**Long Mott Generating Station
Preliminary Safety Analysis Report**

CHAPTER 2

SUBSECTION 2.4.13 ACCIDENTAL RELEASES OF LIQUID EFFLUENTS INTO GROUND
AND SURFACE WATERS

Figure 2.4.13-1
Facilities Particle
Tracks (Sheet 1 of 3)

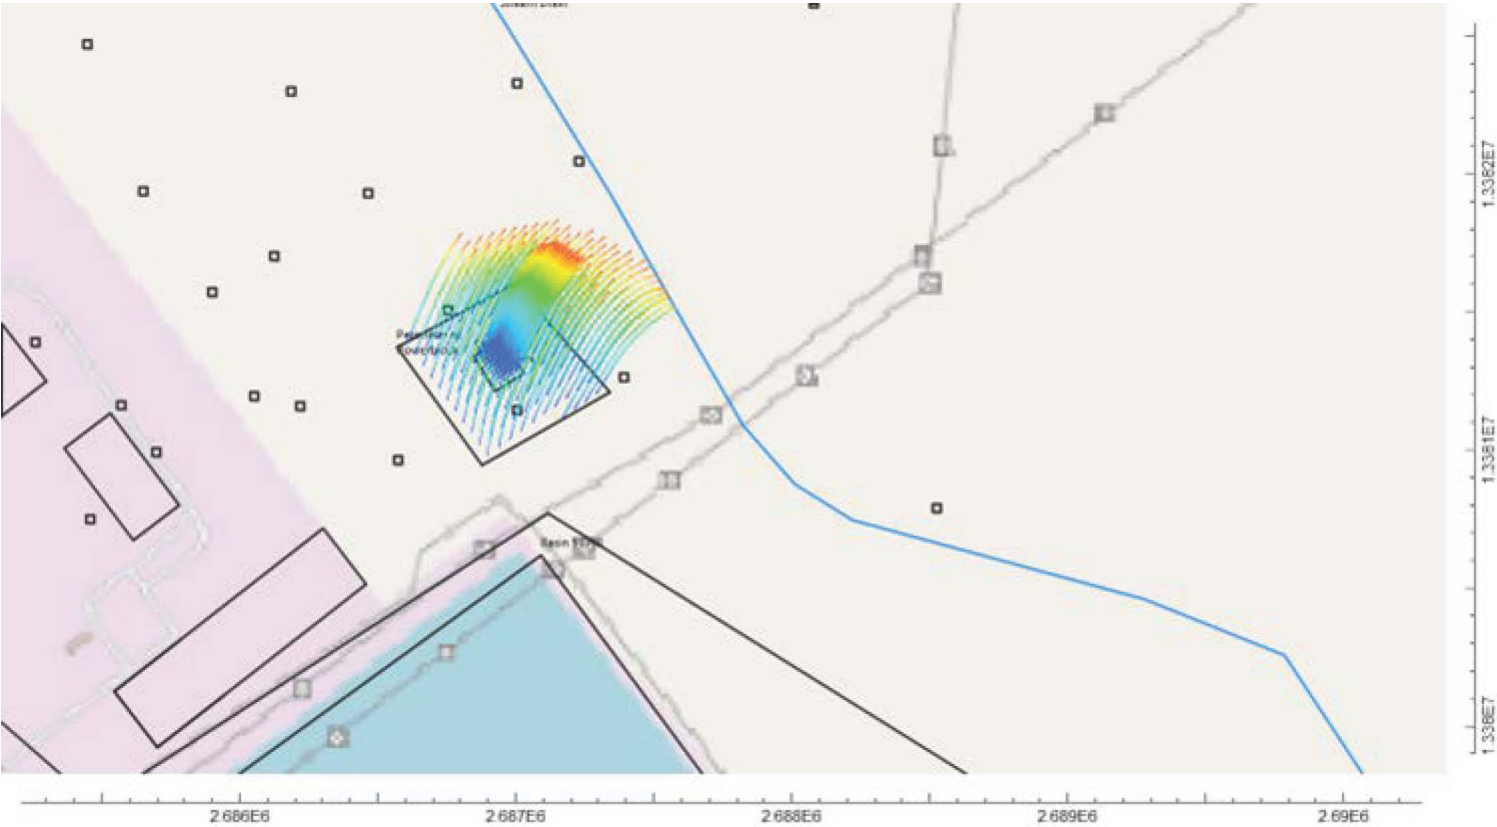
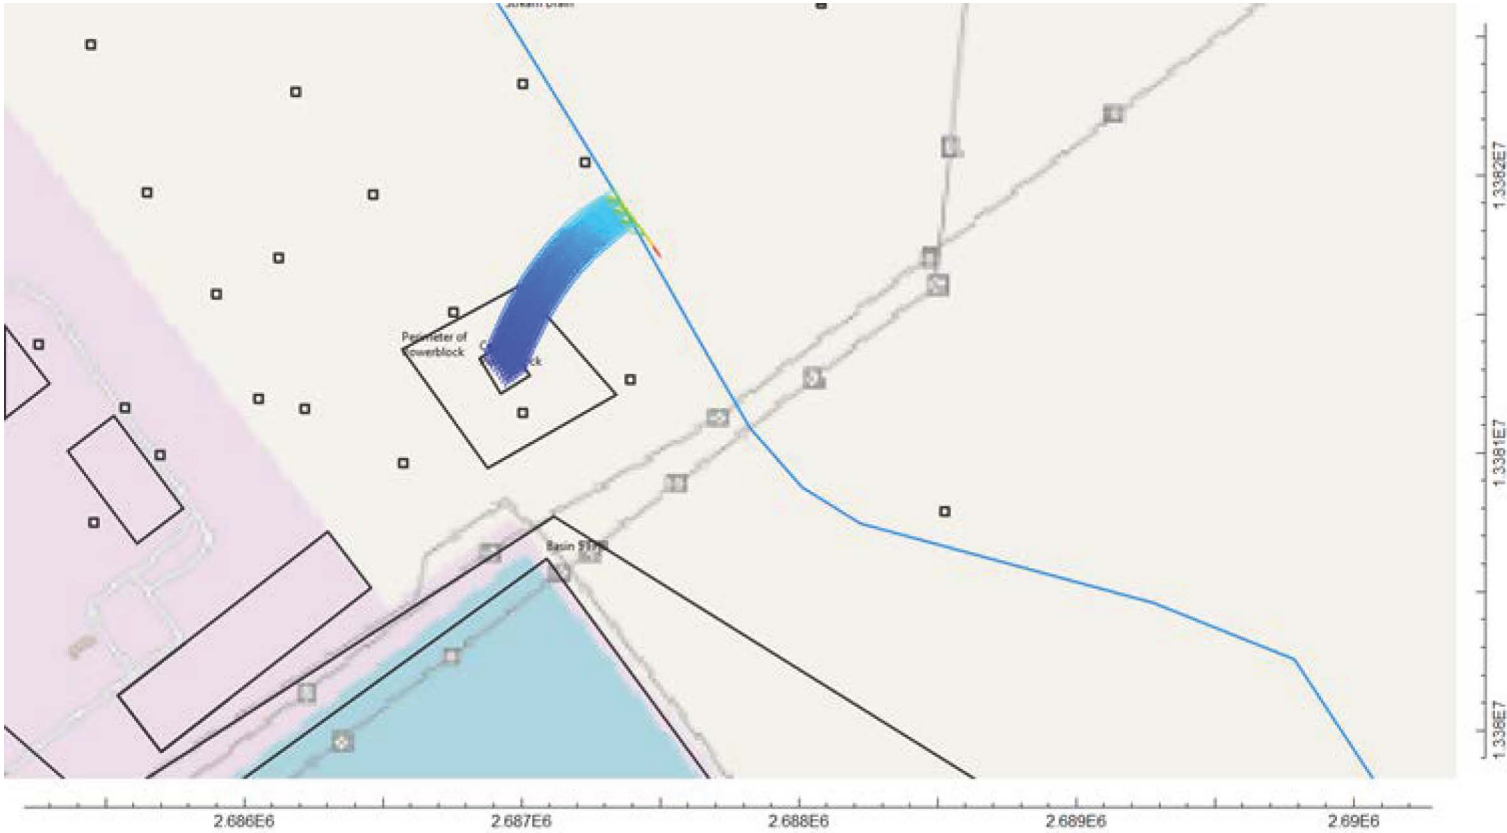
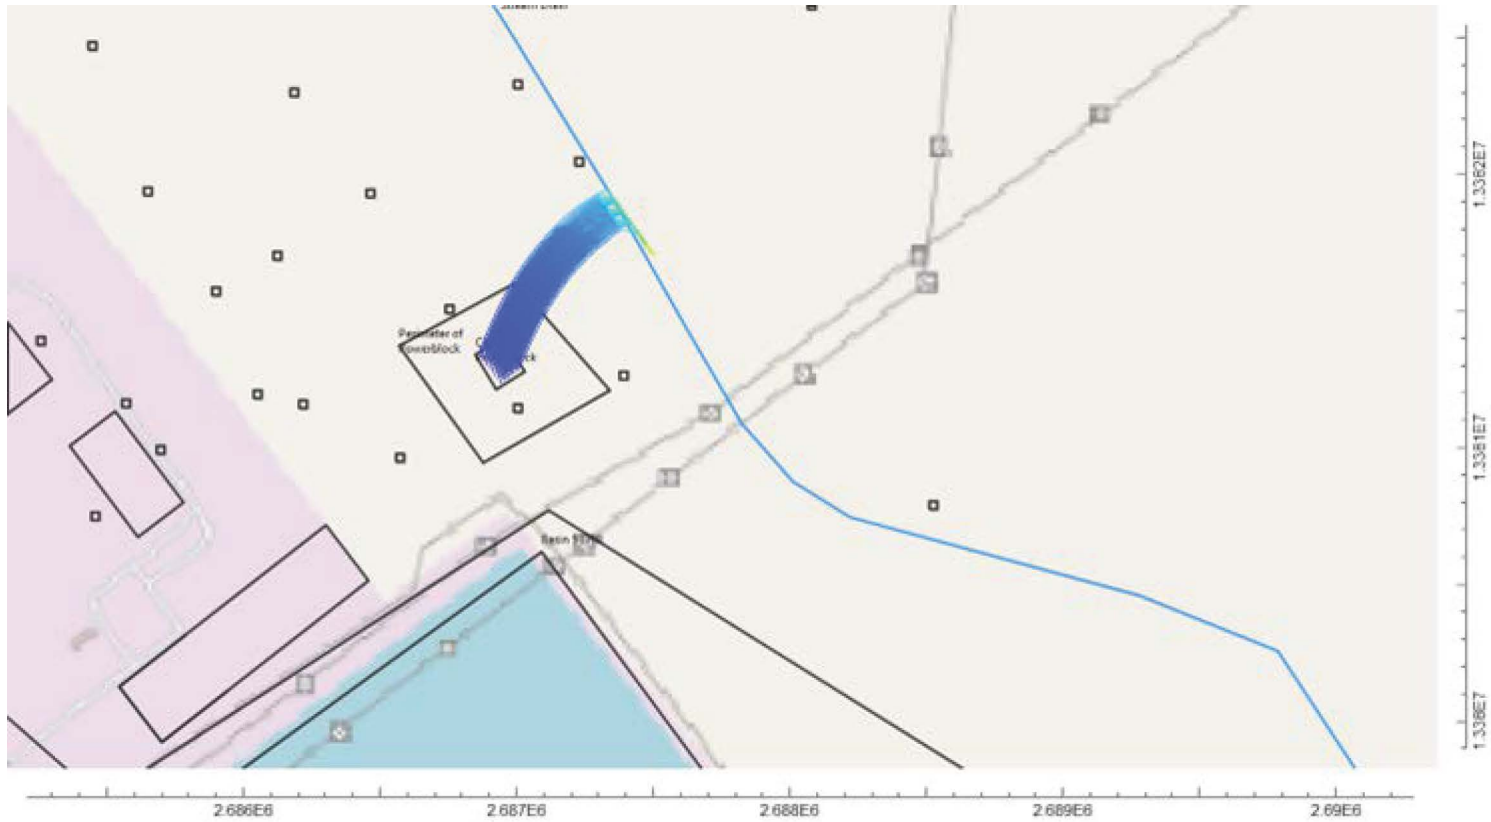
According to the MODFLOW/MODPATH simulation, it takes approximately ~~22~~ 11.6 years for the first of the unattenuated particles to reach the vicinity of the creek drain cells representing West Coloma Creek ("creek"). The particles from the eastern corners reach the creek drain more quickly than the western corners' particles, which are still essentially within or near the boundaries of the Nuclear/Conventional Island by the time the eastern corners' particles have reached the creek

drain. Travel times for the other two scenarios were approximately 61 and 106 years, respectively.

Results of the particle tracking are depicted ~~in~~ Figure 2.4.13-1.

Figure 2.4.13-2
Facilities Corners Particle Track After 20 Years

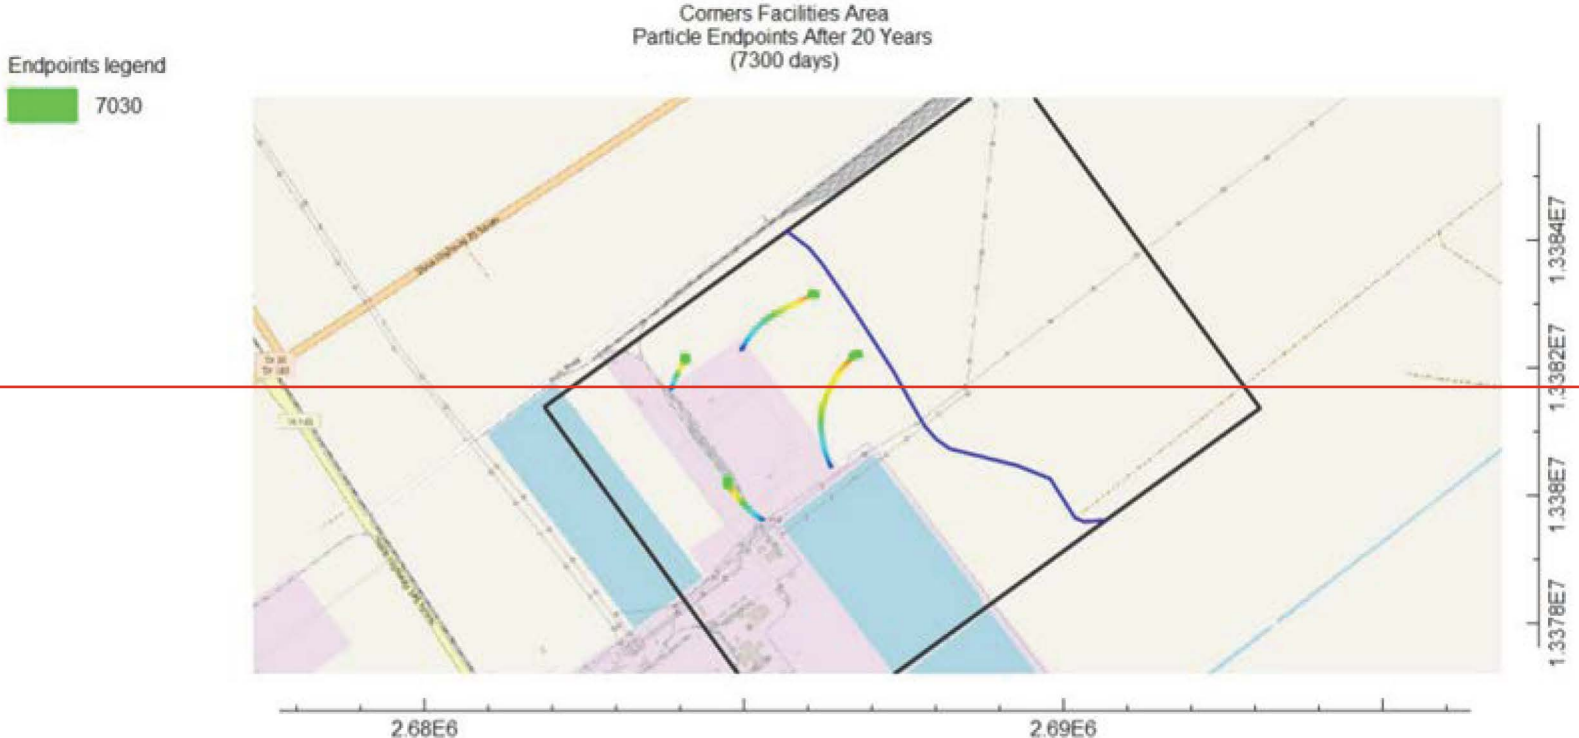
A ~~more formal~~ sensitivity study on the response of the particle tracking analysis included rerunning the tracking simulation with nine particles seeded all across at each of the the four corner locations of the Nuclear/Conventional Island area, and then tracking and noting the location of potential receptors at the creek and their fastest and median travel times. In addition, a hypothetical ½ shortest travel time was calculated and a unity rule value calculated as an additional sensitivity analysis. This was for sensitivity analysis only and does not represent a plausible travel time in this analysis.

Reviewing the particle tracks suggests the particles in the corners closest to the creek drain move quickly and would arrive before particles from the two more distant corners. Results of the particle tracking sensitivity analysis (including the additional particle initiation locations) are depicted on Figure 2.4.13-~~1,2~~. As noted above, major changes in the initial positions of potential release points affect travel time and can affect the exact location of discharge into the creek. More specific location(s) for potential release would refine estimates of travel and discharge point(s) into the creek.-
